NL-08-0670

Vogtle Electric Generating Plant
Supplemental Response to NRC Generic Letter 2004-02

Vogtle Electric Generating Plant Supplemental Response to
NRC GL 2004-02
(Non-Proprietary)

Figure 3.a.3-1 Postulated Break Locations

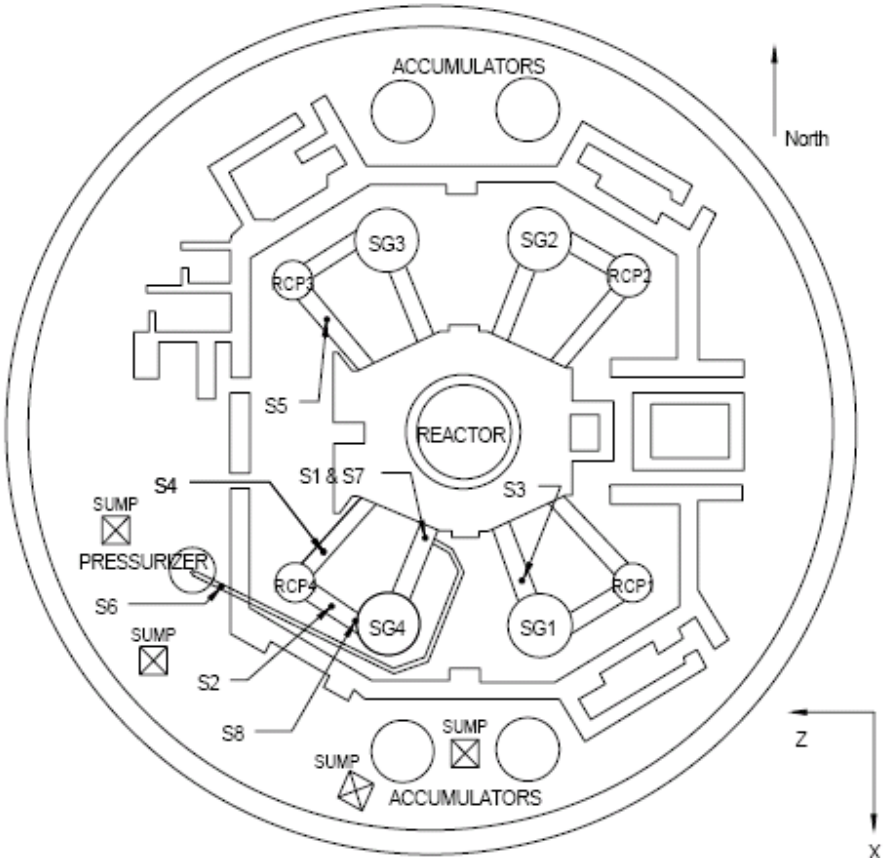
SNC Response to 3.a.3:

location of the break is at the pressurizer surge line connection to the loop 4 hot leg. For Region II of the alternate methodology, the debris quantities are the same as for the deterministic methodology.

Figure 3.f.1 – 1
Emergency Core Cooling System Composite

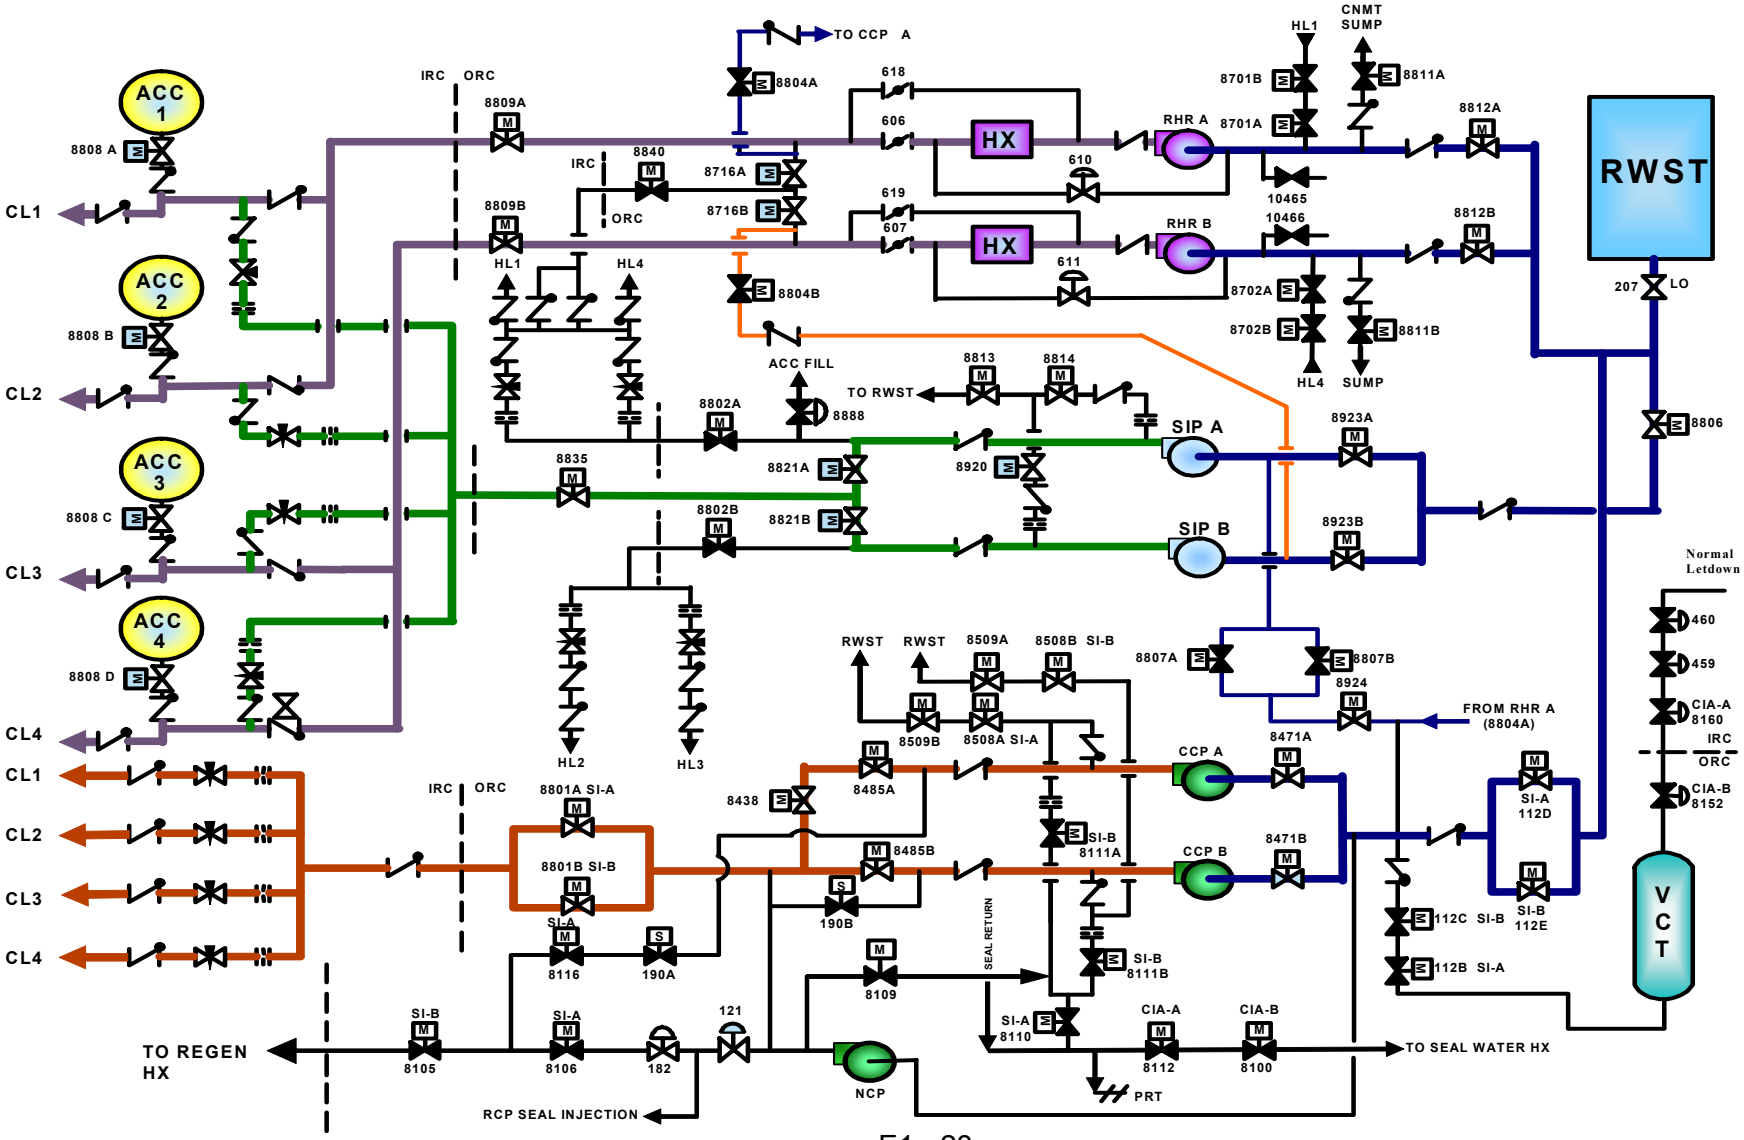
1) Provide a schematic diagram of the emergency core cooling system (ECCS) and containment spray systems (CSS).

See Figure 3.f.1-1 for Emergency Core Cooling System Composite and Figure 3.f.1-2 for Containment Spray System Composite.
